Final Environmental Impact Report  
**Fifth Avenue Landing Project and  
Port Master Plan Amendment**

San Diego Unified Port District  
3165 Pacific Highway  
San Diego, CA 92101

**OCTOBER 2020**  
(UPD #EIR-2016-06; SCH #2016081053)

Volume 1 of 3

**Figure 3-2  
Project Trip Distribution**

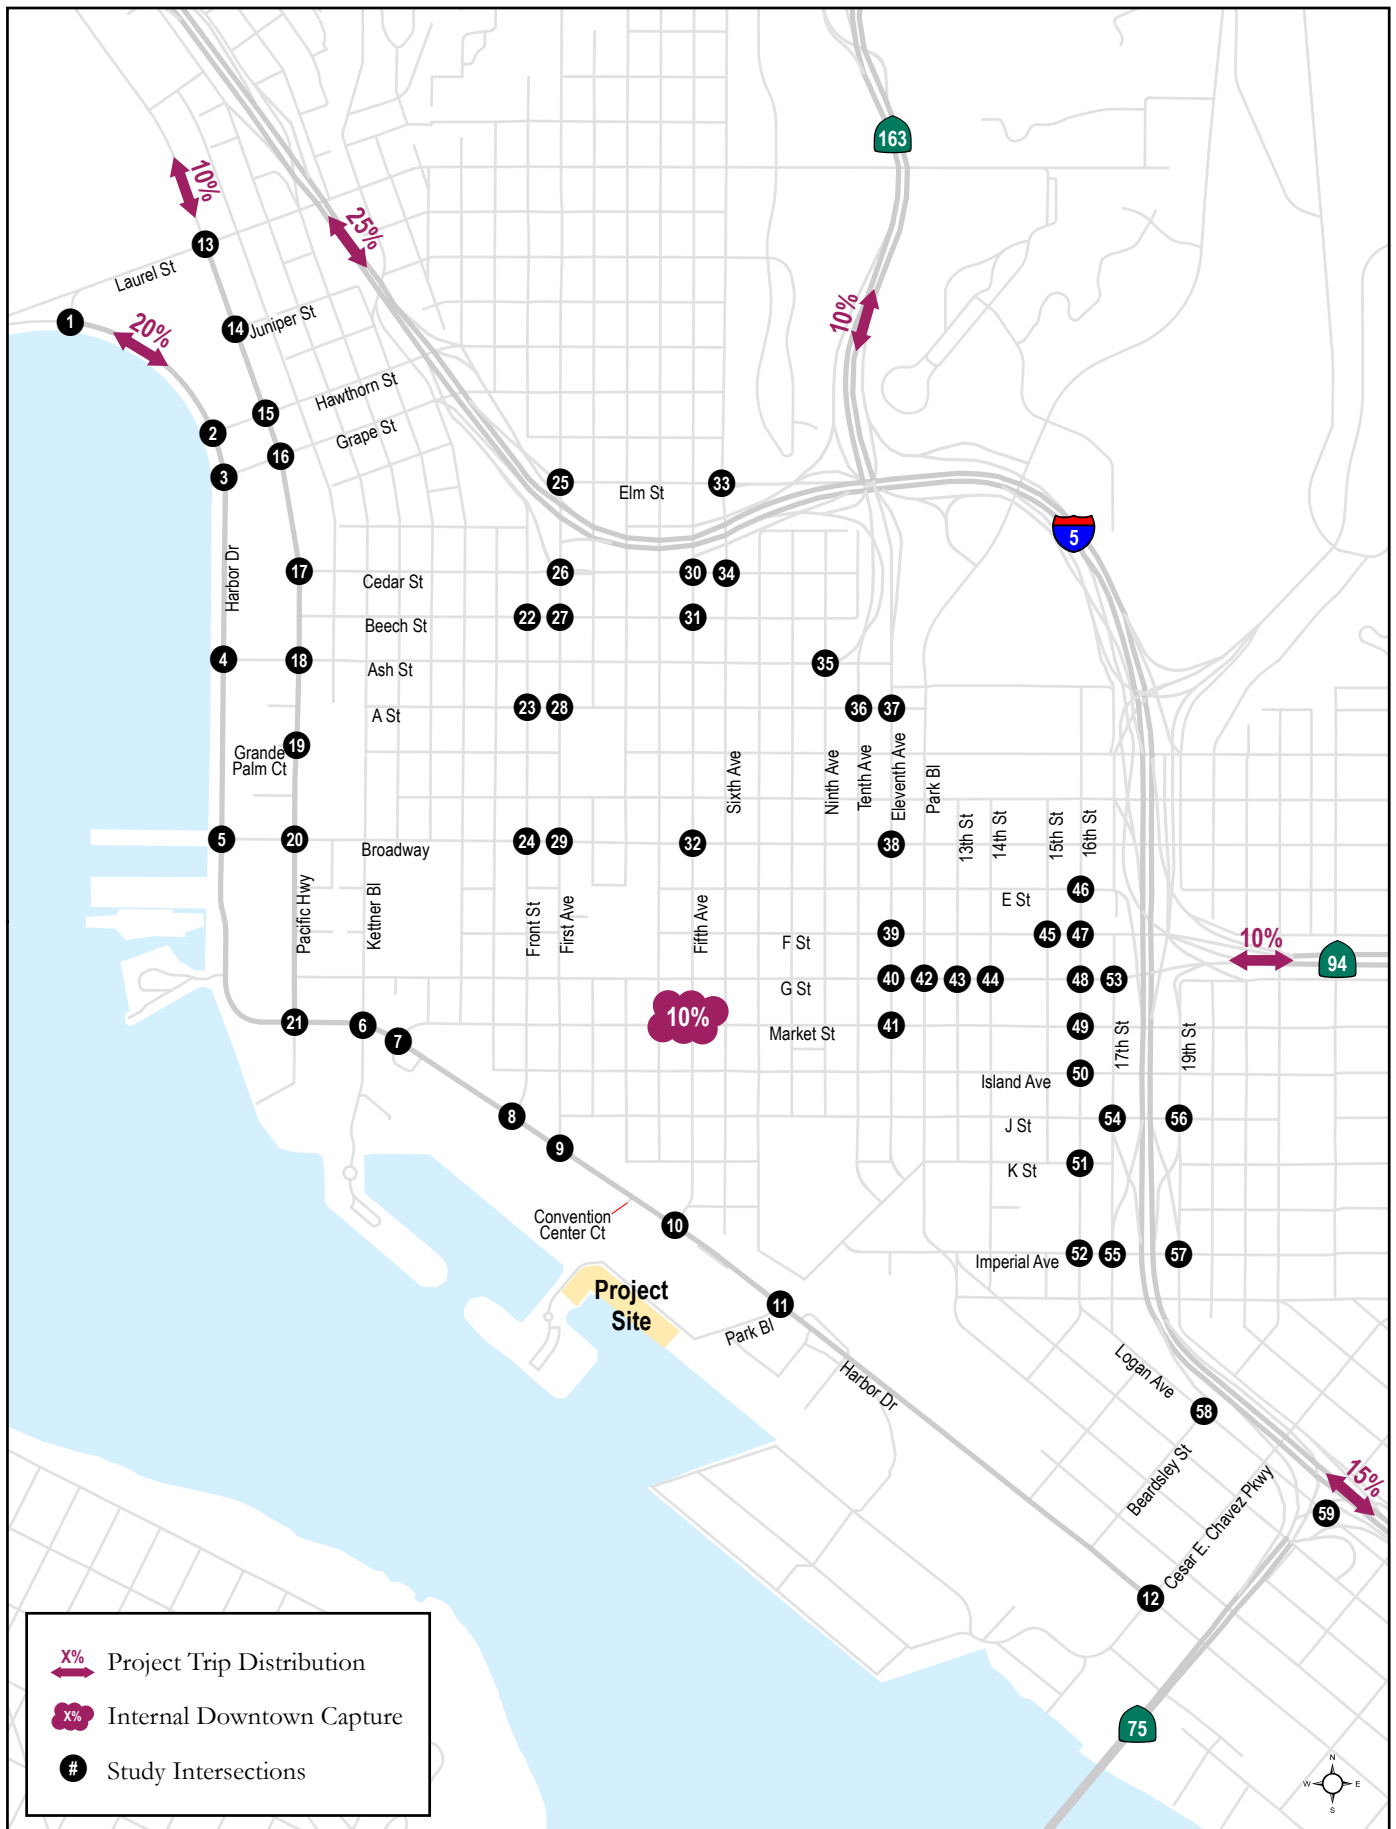
3. The project distribution shown on Figure 3-2 'Project Trip Distribution' includes 10% of internal downtown capture. Assuming this 10% is vehicle traffic, the project trip distribution adds up to 110%. Please clarify.

- D-4 3. The project distribution shown on Figure 3-2 'Project Trip Distribution' includes 10% of internal downtown capture. Assuming this 10% is vehicle traffic, the project trip distribution adds up to 110%. Please clarify.

There was a typographical error on the figure; the project trip distribution adds up to 100%. Figure 4.12-2 of the Draft EIR and Figure 3-2 of the TIA (Appendix K-1 of the Draft EIR) have been revised to indicate that the project trip distribution adds up to 100%. This revision does not result in any changes to the analysis or conclusions in the TIA or the EIR. These changes are included in Chapter 5, *Errata and Revisions*, of the Final EIR.
